STAFF REPORT: MARCH 13, 2023, REGULAR MEETING

APPLICATION NUMBER: HDC2024-00066

ADDRESS: 350 MADISON

SCOPE: REPLACE FIRE ESCAPE, ALTER FENESTRATION

Elevation showing existing conditions; image from application materials.

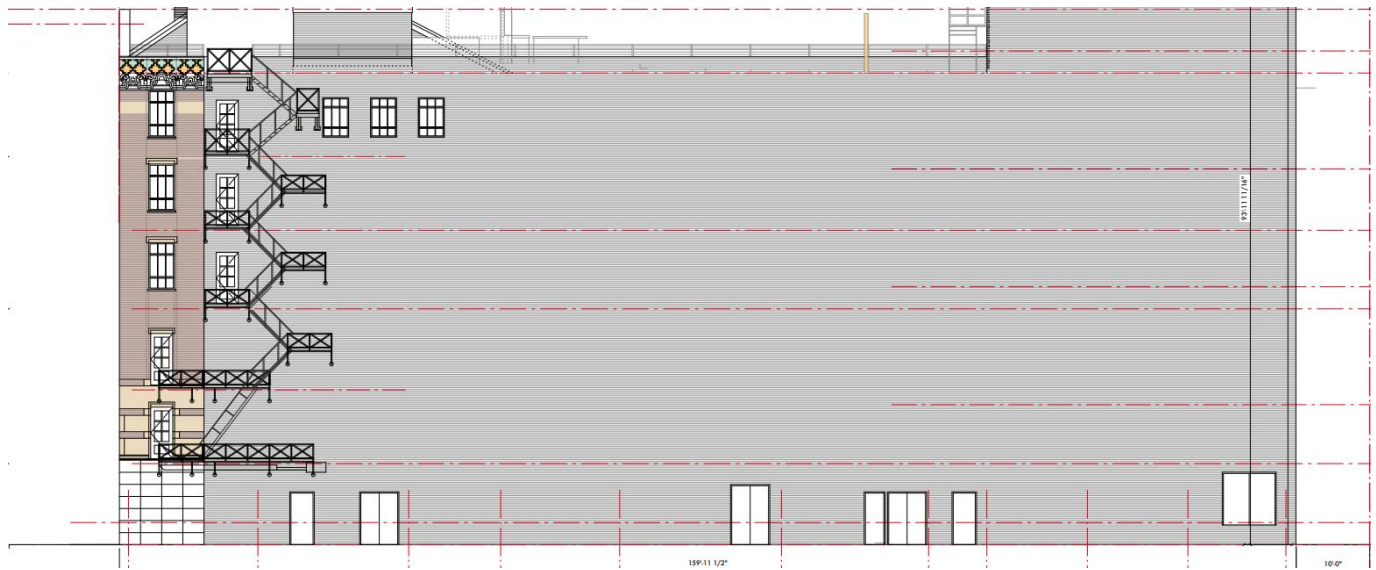
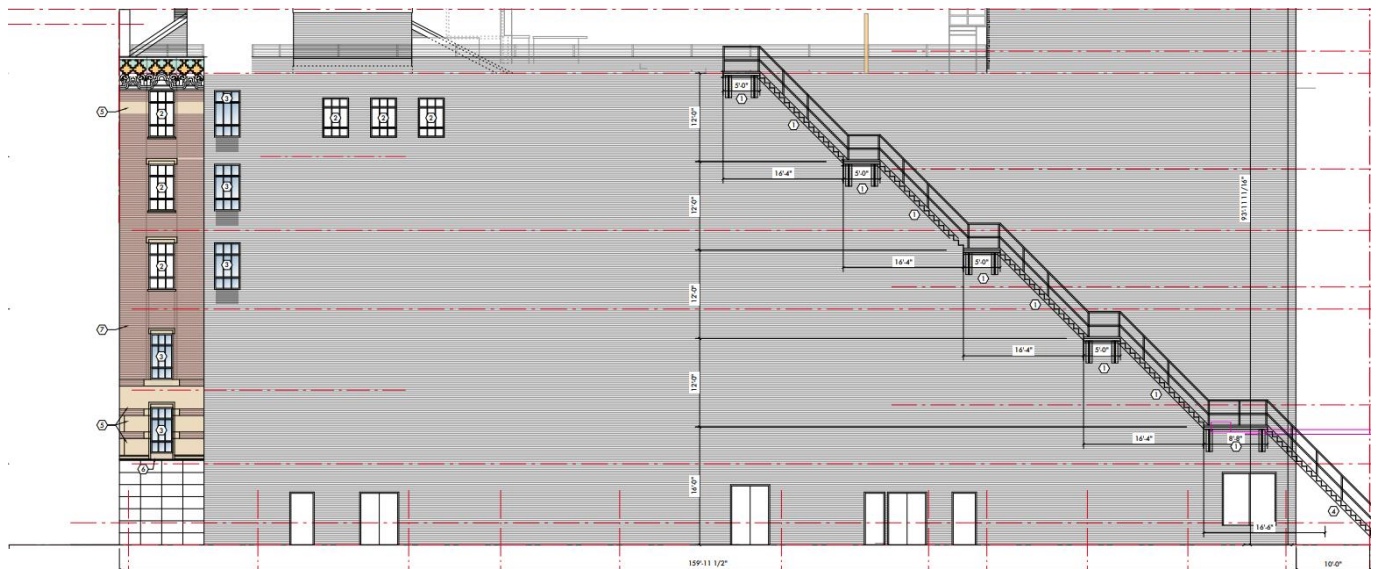
- As mentioned above, staff opinion is that the fire escape is a character-defining feature. Its removal would be contrary to Standard #2 (applicable Standards are quoted in full below): “The removal of historic materials or alteration of features and spaces that characterize a property shall be avoided.” As long as the fire escape remains in place, alterations of associated door openings would also constitute the removal of a character-defining spatial relationship.

- If the Commission were to approve the removal of the fire escape, the treatment of the five associated door openings would also be a concern.
 - The elimination of the door openings would visually imply that the fire escape never existed, creating a “false sense of historical development,” contrary to Standard #3.

- Although minor changes to fenestration on less prominent, secondary elevations are sometimes warranted, such as to meet egress needs, provide an accessible entrance, or to connect an addition, there is no such rationale here.

- There is a discrepancy in the submitted drawings. The enlarged window elevation shows windows that are four panes tall, while the alley elevation shows all window as being three panes tall. Were the replacement of the doors with windows to be approved, the configuration of each window should correspond with a comparable window on the front façade. For reference, façade has windows on the third and fourth floors that are four panes tall, while the windows on the first, fifth, and sixth floors are three panes tall.

- The existing fire escape should be preserved as it is historic (original to the building) as well as character-defining due to its visual prominence in a highly visible and architecturally treated location.
- The existing five door openings subject to this application should be preserved, as they are components of a character-defining spatial relationship.
- Converting doors to windows, absent a compelling rationale, would create a false sense of historical development.

Staff recommends that the Commission issue a Certificate of Appropriateness for the proposed new fire escape as it meets the Secretary of the Interior’s Standards for Rehabilitation.
